INSTALL BLISTER FR 65-79

PLAN

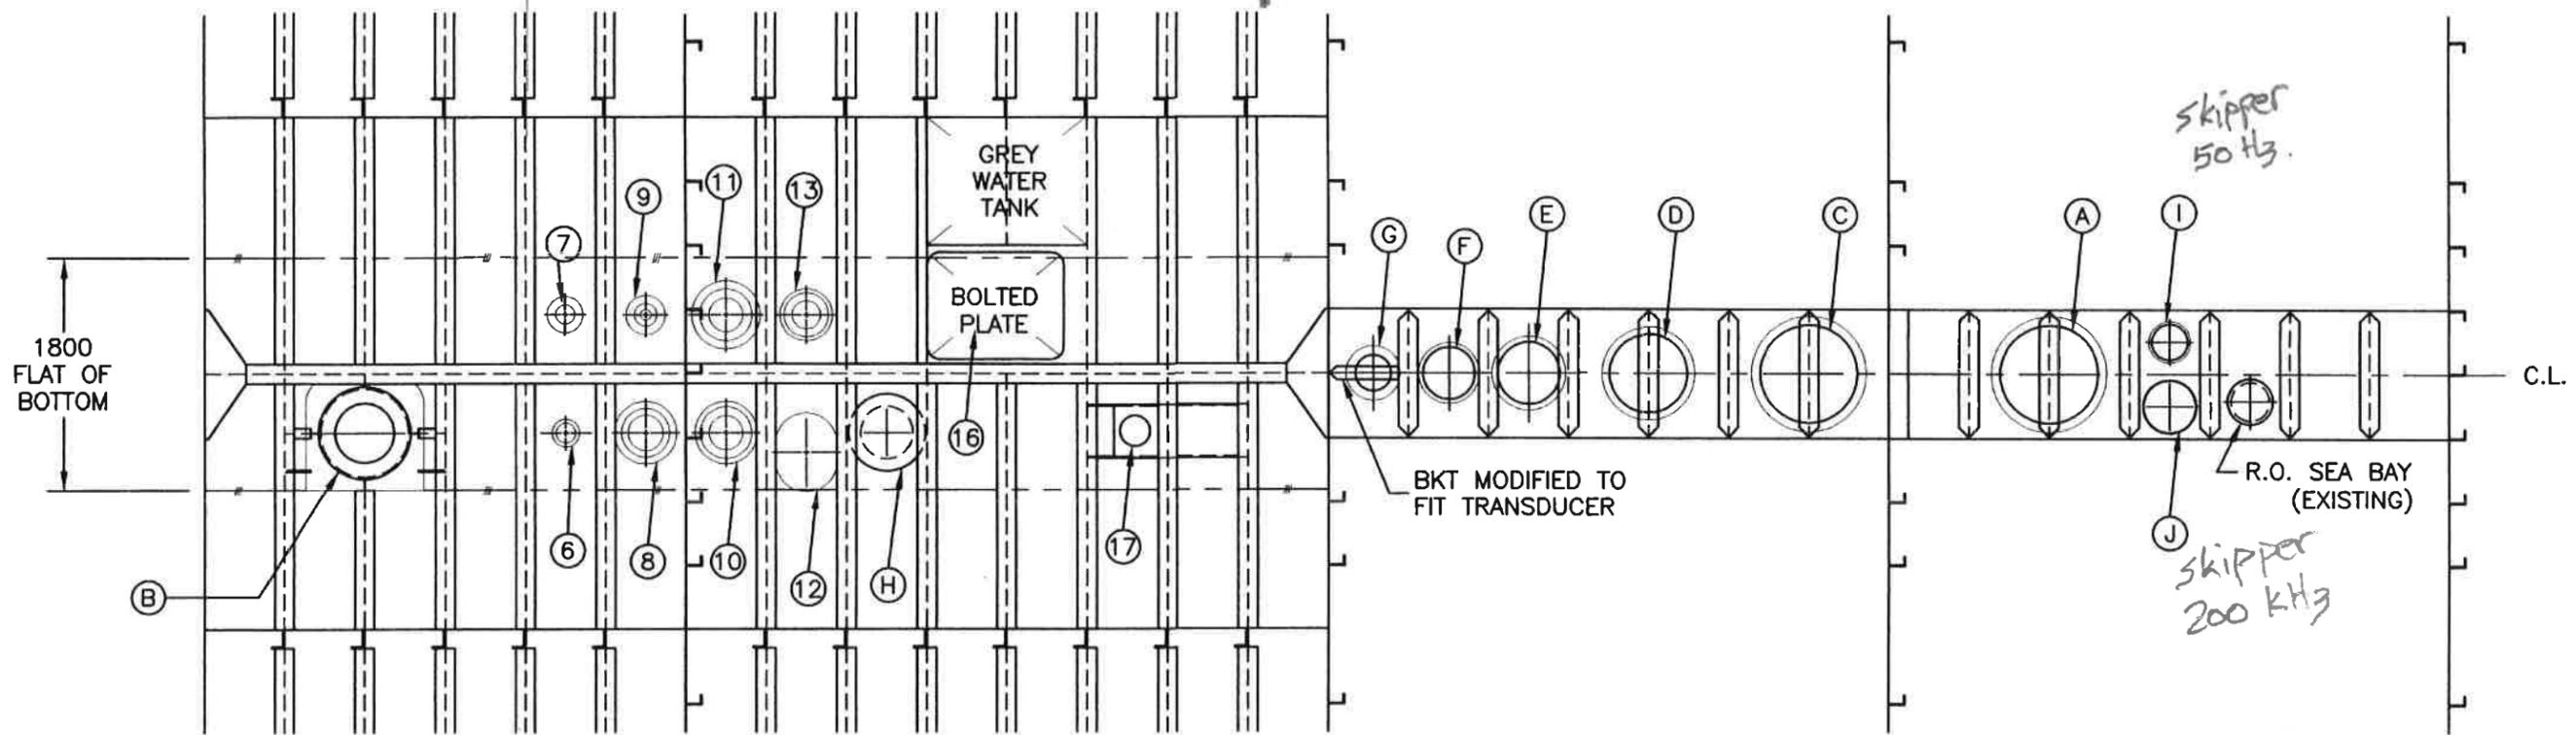
REMOVE

12 kHz SINGLE BEAM
REMOVE RAM KEEP TRANSDUCER

ADCP ARRAY Doppler
MODIFIED ARRANGEMENT

75 kHz
MOVE TO BLISTER
AS FAR AS POSSIBLE AWAY FROM EK60
